TRANS/WP.29/GRRF/2004/24
9 July 2004

PROPOSAL FOR DRAFT AMENDMENT TO REGULATION No. 30

(Pneumatic tyres)

Transmitted by the experts from the European Tyre and Rim Technical Organization (ETRTO)

"3.1.12. The symbol below if the tyre is a "run flat tyre", where "h" is at least 12 mm.

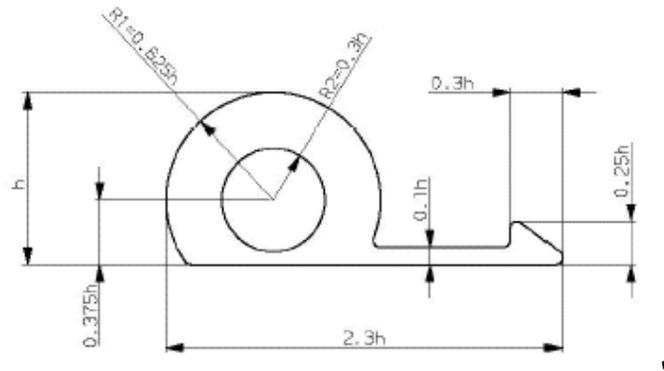
Insert a new paragraph 3.1.12., to read:
